SUBJECT: Historic Area Work Permit #1143222—Fenestration alterations

The Montgomery County Historic Preservation Commission (HPC) has reviewed the attached applications for a Historic Area Work Permit (HAWP). This application was **approved with one (1) condition** at the December 17, 2025 HPC meeting:

Applicant: Sarah Greenberg; Richard J. Vitullo, Architect  
Address: 50 Philadelphia Avenue, Takoma Park

# AWNING

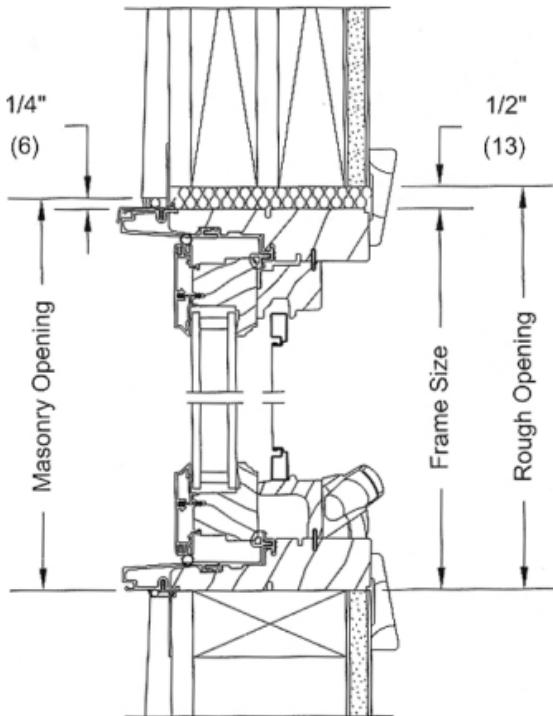
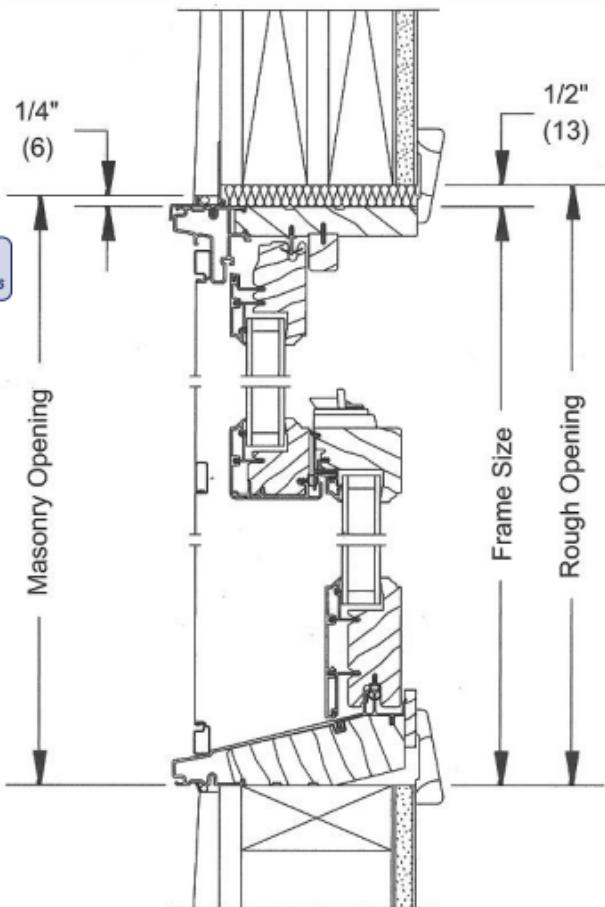
1. The windows must have simulated-divided-lights and the exterior trim must have a painted finish.
